PLANNING COMMISSION
REGULARLY SCHEDULED MEETING
THURSDAY, JULY 13, 2017
6:30 – 9:00 PM
COUNCIL CHAMBER
280 MADISON AVE N
BAINBRIDGE ISLAND, WA 98110

STAFF REPORT

Project: Creative Space Site Plan and Design Review

File Number: PLN50177SPR

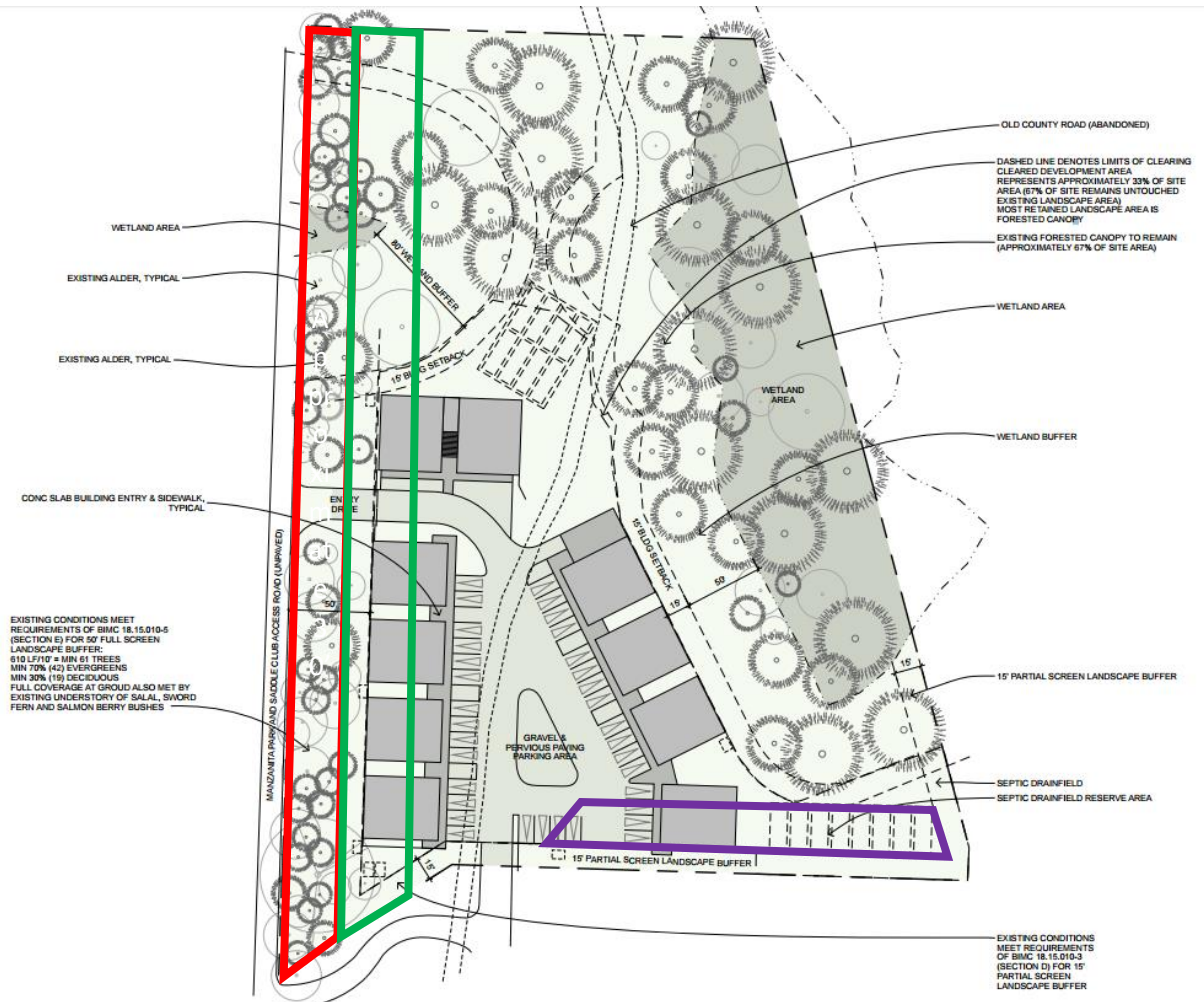
The property abuts a private road that is shared with the Saddle Club. The road is accessible with a 60' access easement, 30' of which are on the subject property. Five of the western most buildings are proposed within the 50' perimeter landscape buffer. A second 50' access and utility easement exists on the southern border of the property, running east/west. The applicant is proposing to include within that easement area one of the buildings, a landscaping buffer, parking, and drainfields. This easement wasn't included in the applicant's proposed site plans. In researching the site, the City discovered the easement and informed the applicant about the existence of the easement. When so informed by the City, the applicant responded by indicating that they would vacate the easement, without specifying how this would be accomplished (reference doc 19).

The property has two wetlands and associated buffers. The site plan does not propose any encroachments into the wetlands and their buffers (reference doc 6). However, stormwater is proposed to discharge to a wetland at the outfall of a replaced culvert proposed to be located opposite the access point along Saddle Club road. The applicant was asked to address the potential impacts on the wetland. This information has not been provided to the City.

□ Approximate 30' easement
 □ Approximate 50' landscape buffer
 □ Approximate 50' easement
